# Technical Bulletin

<b>DP02</b>	<b>TB0042-2011</b>	<b>Élan Motorsports Technologies</b>	
<b>From:</b>	<b>John Harris</b>		
<b>Subject:</b>	<b>2.0L MZR Engine Install</b>	<b>Date:</b>	<b>Nov 22<sup>nd</sup>, 2011</b>

## Attention all Élan DP02 teams

*Figure 1: Bellhousing Shims*

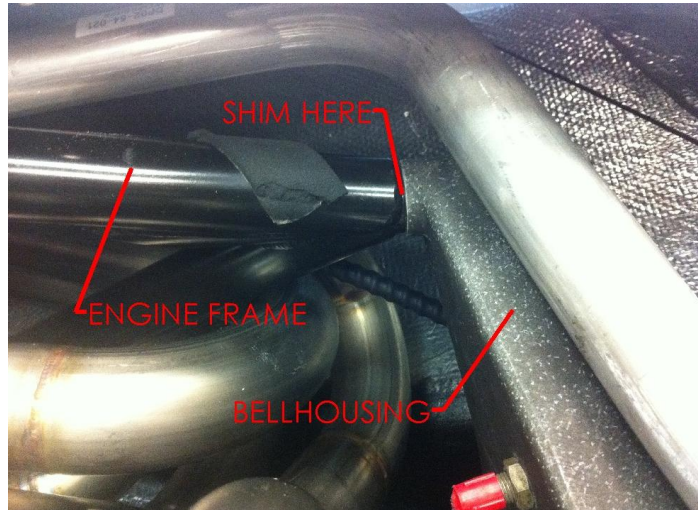
It is worth noting that, due to manufacturing tolerances, all DP02 chassis were originally assembled with the appropriate amount of shims between the bellhousing and engine frame bosses (see Figure 1). This is to ensure the bellhousing does not crack due to stresses induced during installation. The conversion of any DP02 chassis to accept a new motor will inevitably require this shimming process to be repeated.

9. Tighten the three bolts securing the front upper engine mount to the engine.
10. Using a pair of calipers, carefully measure the gap between the bellhousing and the engine frame bosses at all four mounting locations. Acquire the corresponding thickness and amount of shims required to take up the gap at these four locations.

11. Remove bellhousing and engine. Install shims in their appropriate locations.
12. Reinstall bellhousing, engine and included mounts leaving **all** fasteners loose.

*Figure 2: Patch Placement*

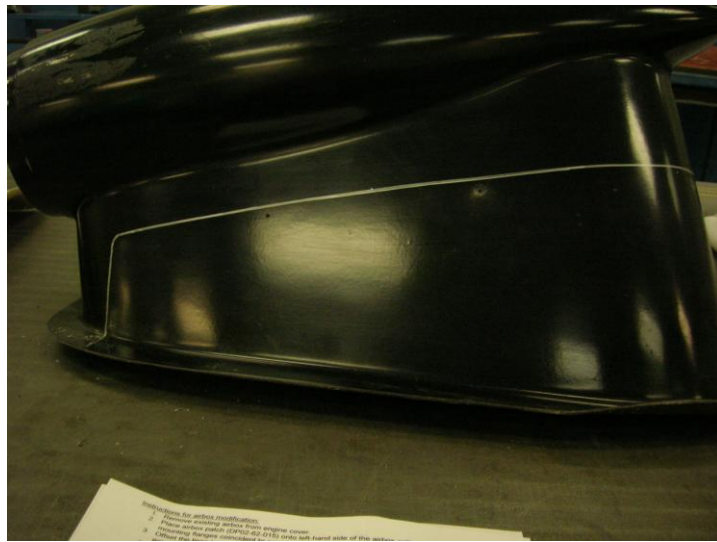
1. Remove existing airbox from engine cover.
2. Place airbox patch (DP02-62-015) onto left-hand side of the airbox, with the two components' mounting flanges coincident to one another (as seen in Figure 2), and trace around its perimeter on three sides (as seen in Figure 3).
